**TOWN OF NEWBURGH
PLANNING BOARD
TECHNICAL REVIEW COMMENTS**

PROJECT NAME: RT ORCHARDS SUBDIVISION
PROJECT NO.: 22-28
PROJECT LOCATION: SECTION 7, BLOCK 1, LOT 26.1/N. OF COLANDREA RD & E. OF FROZEN RIDGE RD
REVIEW DATE: 22 NOVEMBER 2022
MEETING DATE: 1 DECEMBER 2022
PROJECT REPRESENTATIVE: COLLIERS ENGINEERING & DESIGN CT, PC

DIMENSION & GRADING PLAN

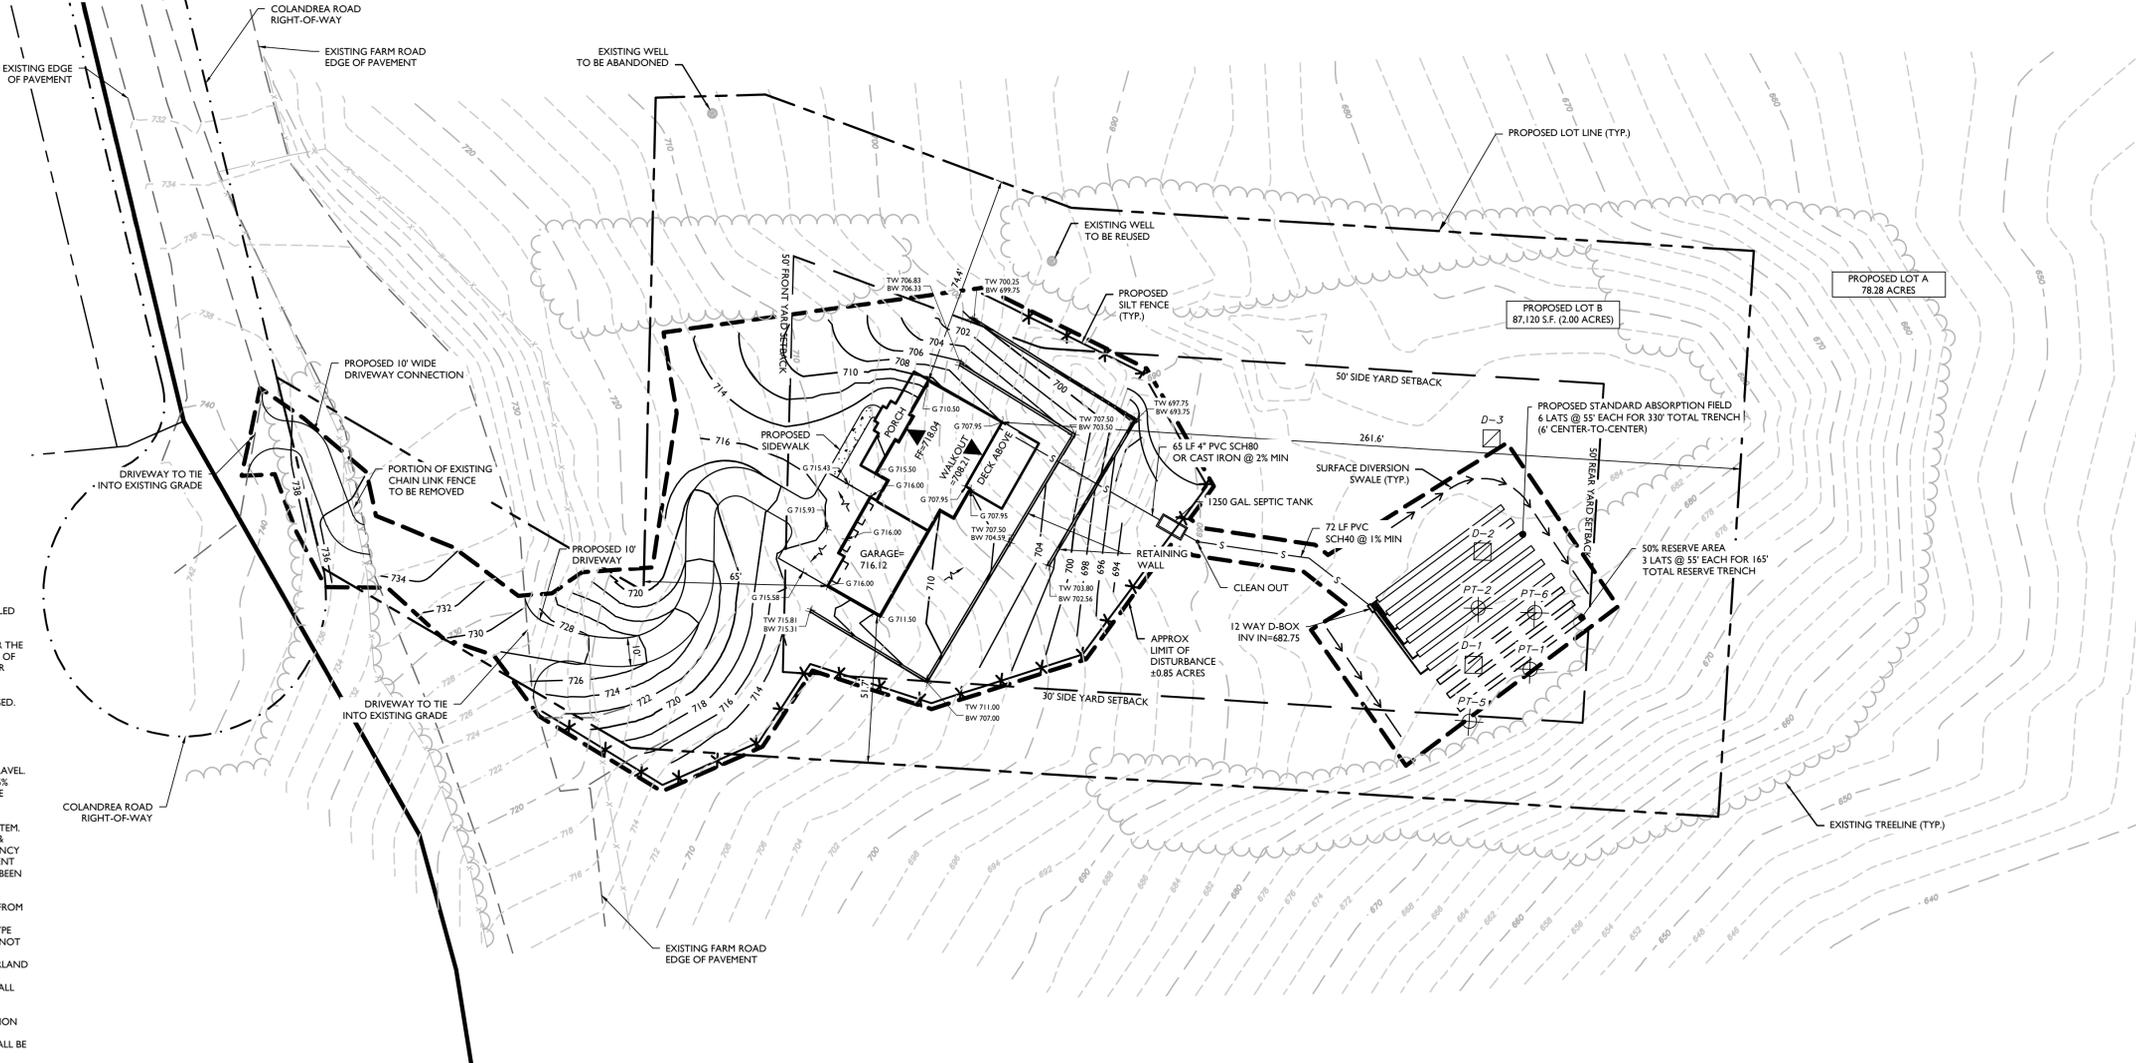
2. Information pertaining to the existing farm road, requirements for access through the existing farm road should be provided.
3. The Septic Note #11 should be modified that an As Built Map and certification must be submitted to the Town of Newburgh Building Department prior to issuance of a Certificate of Occupancy.

6. Grading and silt fence extend off the site in the vicinity of the existing farm road.
7. The applicant's representative are requested to address whether the subdivision was previously utilized as an orchard. Health Department requirements for all former orchard use would apply.
